C1981010, Trapper Mine, PR-11, Groundwater Review

Interoffice Memorandum

**Subject: Trapper Mine (C-1981-010)
PR-11
Groundwater Review**

Figure 1: Screenshot showing currently approved permit boundary (pink polygon) and Map M36 (with core hole locations) overlain on proposed Map M4 (with pit locations)

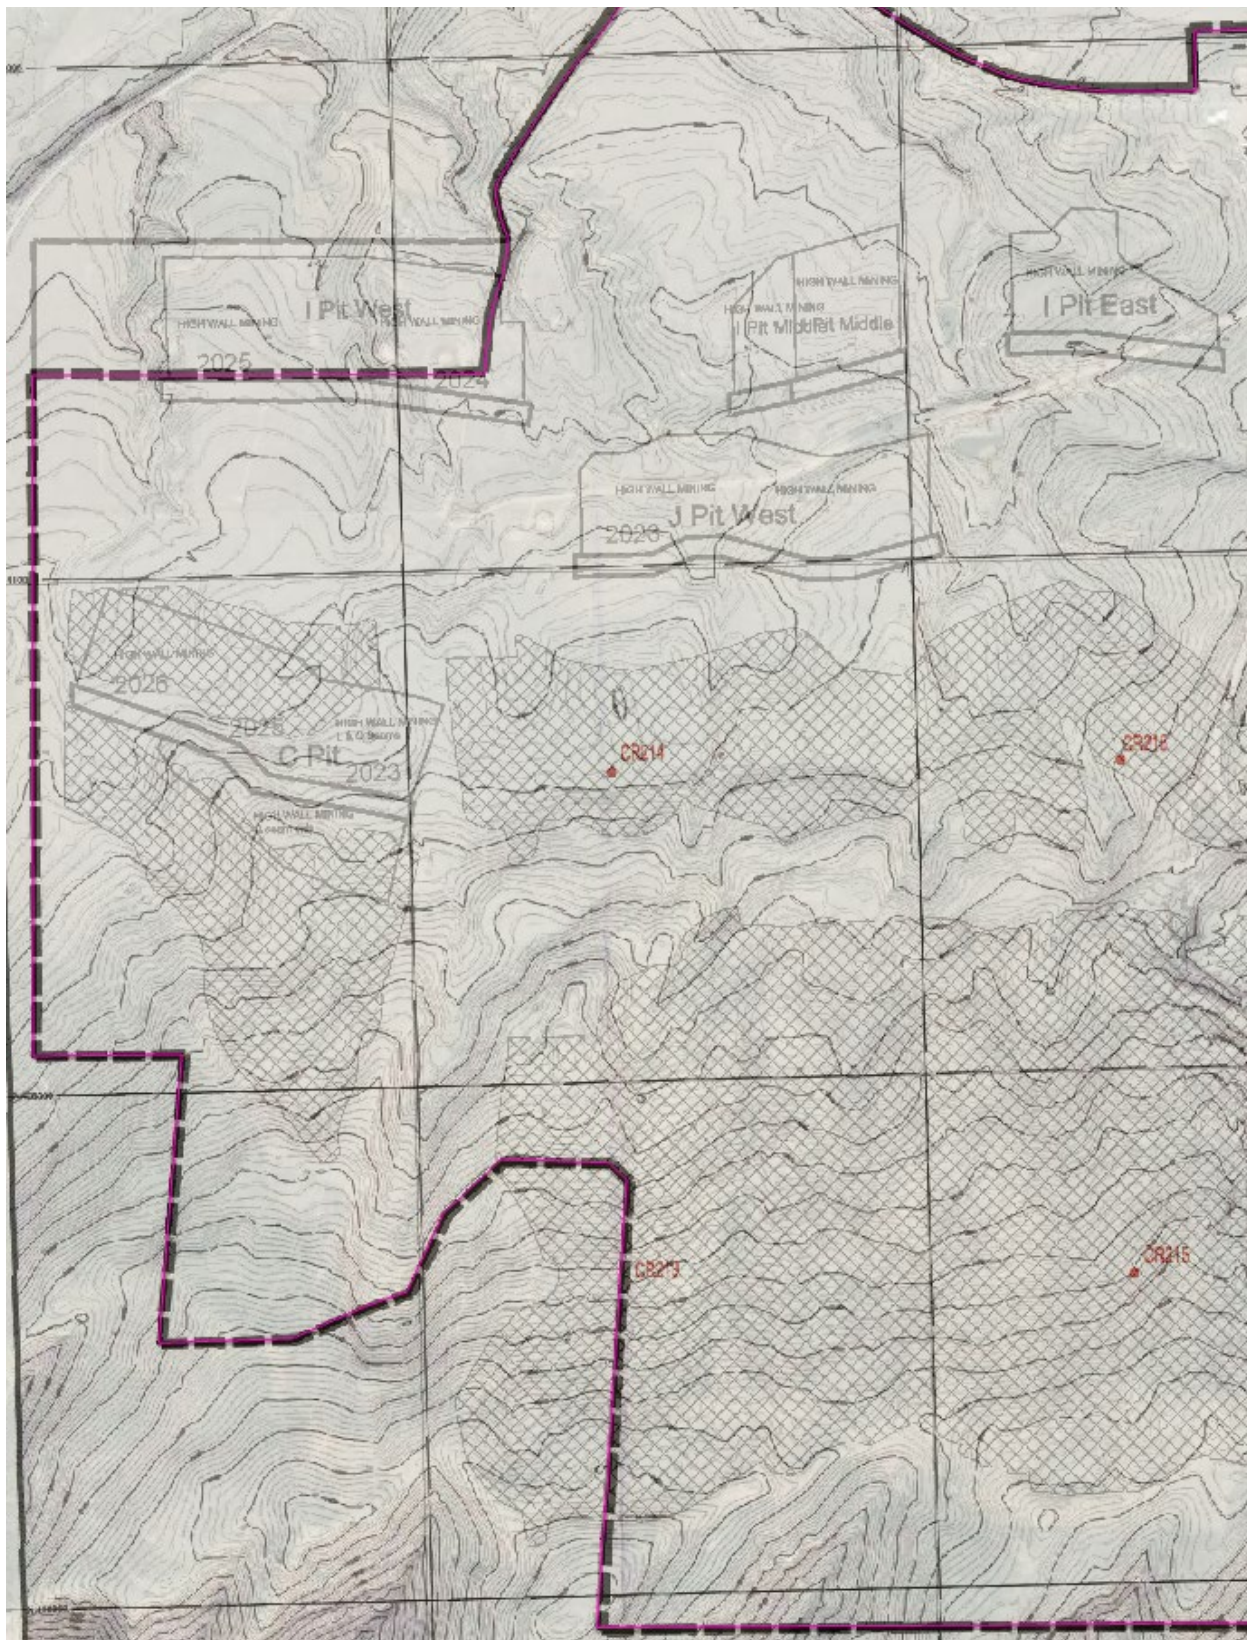
1. Map 36 shows the locations of core holes used to characterize overburden geochemistry, and Section 2.7.2 (Page 2-357) presents the results of the analysis. No revisions to Section 2.7.2 have been proposed with PR-11, and Map 36 shows that few core holes were drilled in the western part of the permit area (see Figure 1 below).

Please update Section 2.7.2 with a discussion of the characterization of overburden geochemistry for the C, I and J Pits.

Figure 2: Screenshot showing currently approved permit boundary (pink polygon) overlain on currently approved Map M54G, with potentiometric surface of Third White Sandstone (red contour lines) and Second White Sandstone (green contour lines)

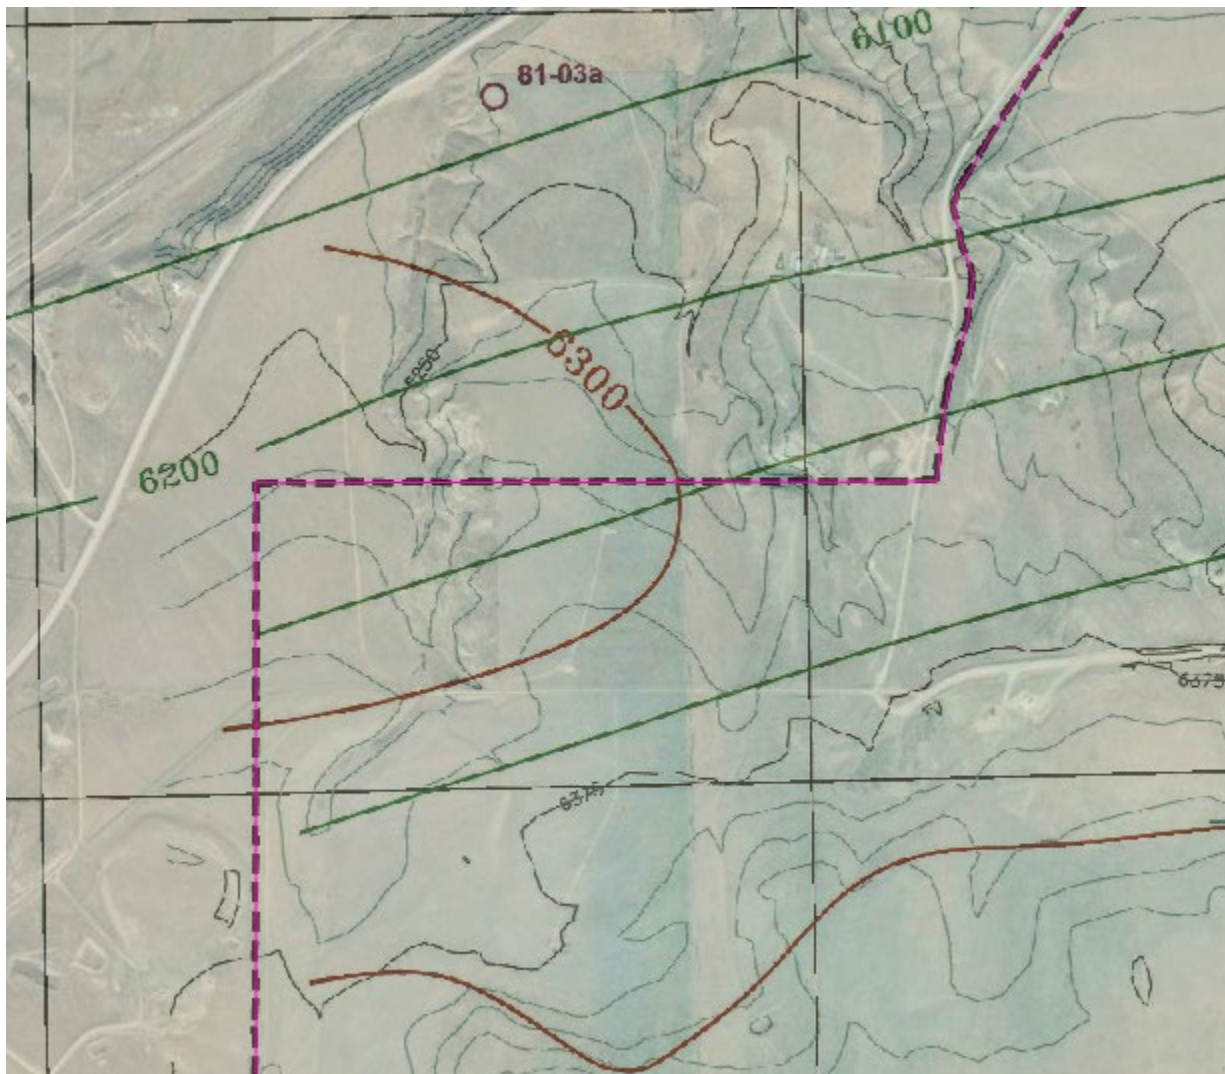
4. The water levels in the Twentymile Sandstone, Third White Sandstone, Second White Sandstone and Alluvial Aquifers are presented on Map 54G, which was last updated with PR-7 in 2014. The map shows projected contour lines at 100' intervals of the potentiometric surface in each of the named aquifers, from which the direction of groundwater flow can be inferred. The map suggests that groundwater flows generally to the NNW across most of the permit area in all three of the identified bedrock aquifers. There is an anomaly in the Third White Sandstone in the region of the PR-11 addition to the permit area (see Figure 2), where the 6300' contour line is shown curving dramatically around by 180°. If this line were accurate groundwater flow in the Third White Sandstone would be to the W, or possibly SW, beneath the proposed I Pit West, and neither of monitoring wells 81-03A or CY-3 would be downgradient of the proposed disturbance. Based on the information available in the PAP, the Division finds the projected potentiometric surface shown on the currently approved Map 54G implausible, particularly given that no such anomaly is shown in the Second White Sandstone which overlies it. According to Figure 2.7-4 (page 2-356) the axis of the synclinal basin is approximately 2 miles to the north, so there is no structural rationale.

Given that the Third White Sandstone is immediately below the G-seam (according to figure 2.7-18p, page 2462b), further characterization of this aquifer in the PR-11 area is warranted.

Characterization of the the alluvial aquifers in the three drainages in the west of the permit area appears to be lacking.

- (a) Please discuss the anomaly in the Third White Sandstone aquifer described above.
 - (b) Please update Map 54G with the most recent data available to show the best possible prediction of the potentiometric surface in each of the named aquifers. (It may be necessary to collect data from another point south and west of 81-03A and CY-3)
 - (c) Depending on the response to (a) and (b), please propose an additional downgradient monitoring well in the Third White Sandstone if necessary.
 - (d) Please discuss the characterization of the alluvial aquifers in the west of the permit area.
5. There is currently no map in the PAP which shows location of the outcrop of the various aquifers identified within the permit area (or the coal seams).

It would make an assessment of the probable hydrologic impacts on groundwater significantly easier if these outcrop locations were shown on a map; Map 54G would be an ideal candidate. Is it Trapper's assumption that the recharge zone for each of these aquifers is at or near the outcrop?
